E7515A-01B

Modification Recommended Service Note

E7515A UXM Wireless Test Set

Modify the Embedded PC to improve boot reliability.

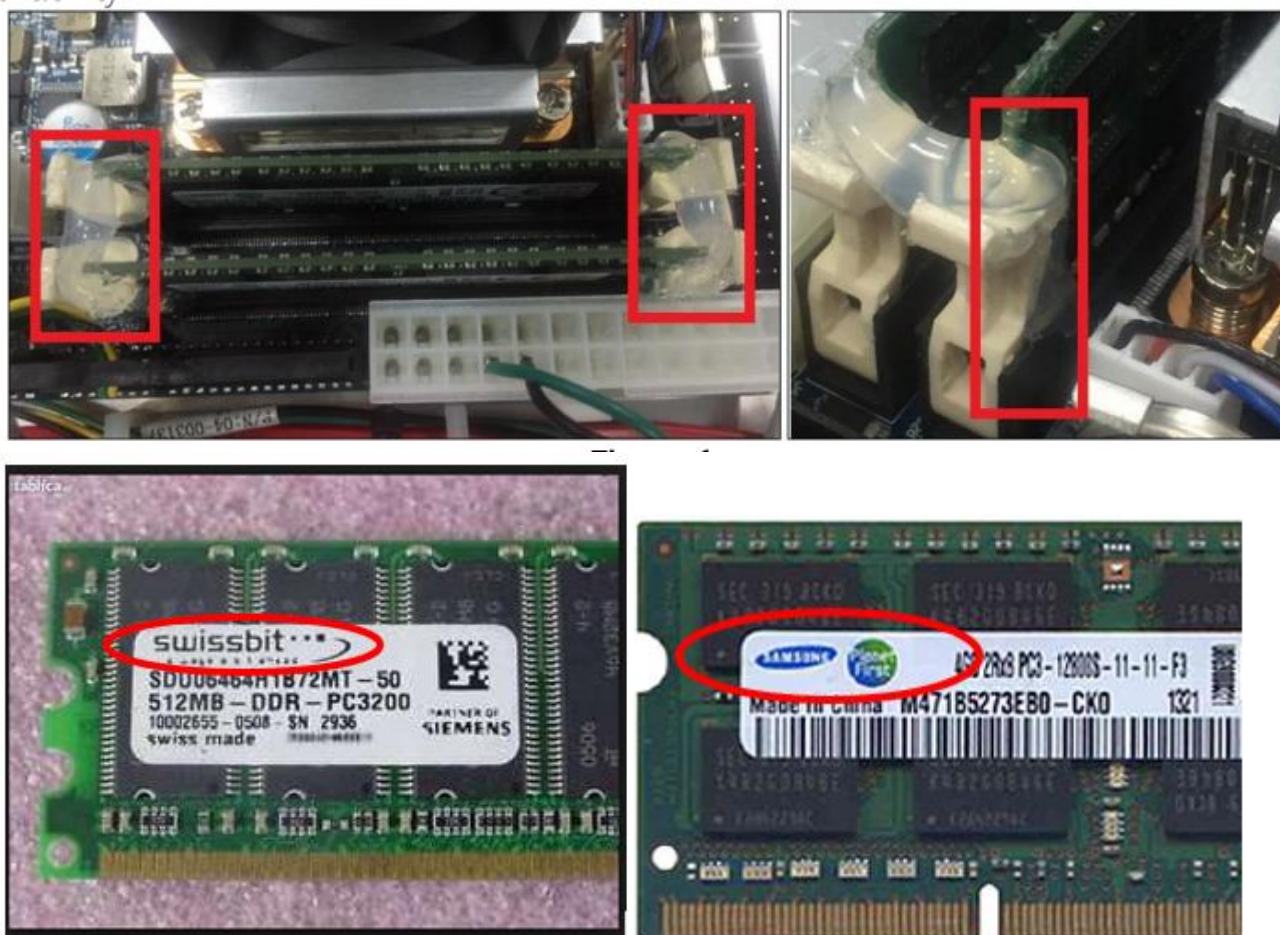
The E7515A will fail to boot if either of the RAM modules on the Embedded PC are not fully engaged in the memory slots or if the gold plating on the RAM modules has been damaged during transportation shock and vibration.

A design change from MY5716xxxx onwards was implemented to improve the UXM boot reliability by changing RAM module supplier and changing the locking mechanism used to hold the RAM modules in place.

Extra padding was also added to the underside of the Embedded PC to further dampen the vibration and improve the boot reliability after transportation vibration.

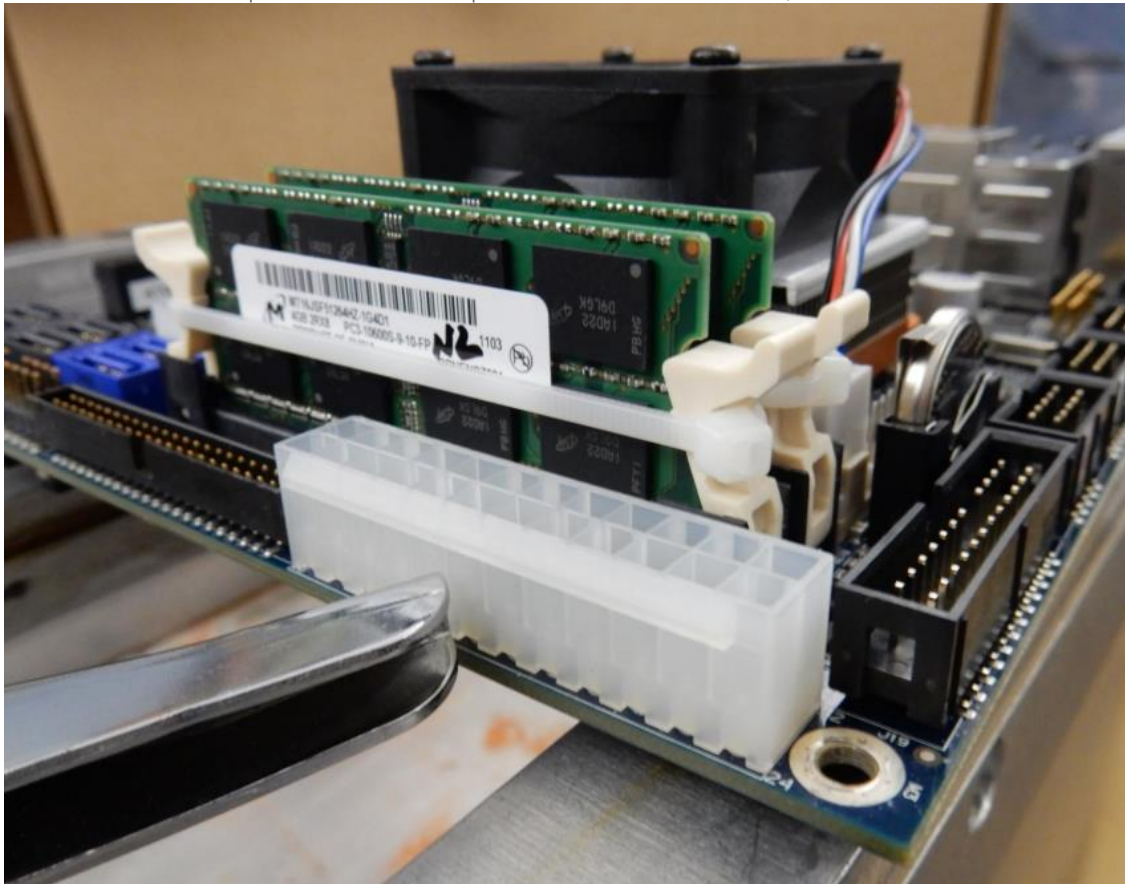
1. Remove the outer covers from the instrument
 2. Remove the Front Panel to fully inspect the RAM modules on the Embedded PC.
 3. Replace any **SwissBit** or **Samsung** DRAM with **Micron** RAM part number - 1819-1185.
- NOTE:** You may need to cut away Glue or RTV holding the existing Swissbit memory in place.

- Secure the RAM in place with ESD Zip Ties - 1400-0482 or equivalent

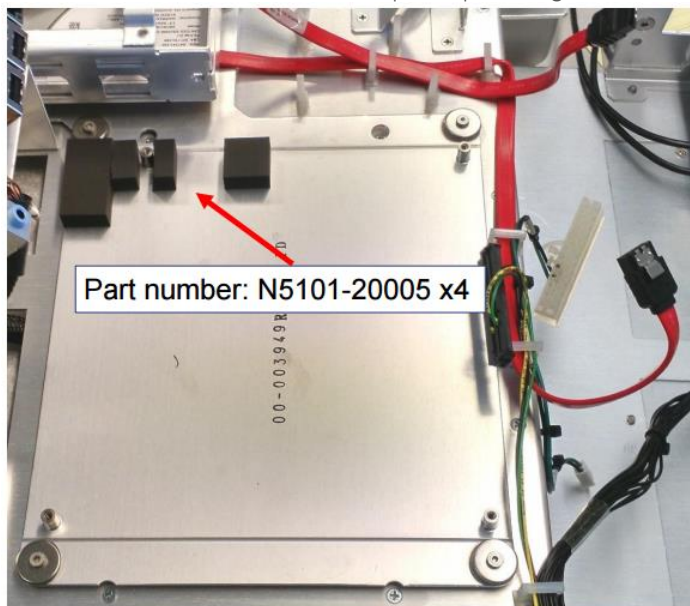
- Inspect the underside of the Embedded PC and add 4x N5101-20005 if not already installed.
NOTE: You will need cut one square padding in half to straddle the standoff

Touchscreen USB Cable (white)

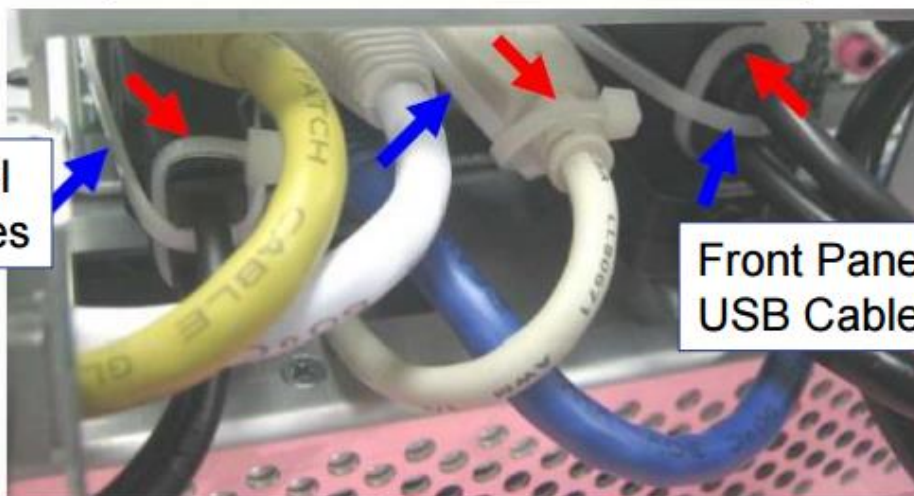
6. Re-install the Embedded PC and attach cables. Add cable ties, 1400-3557, to the USB Cables
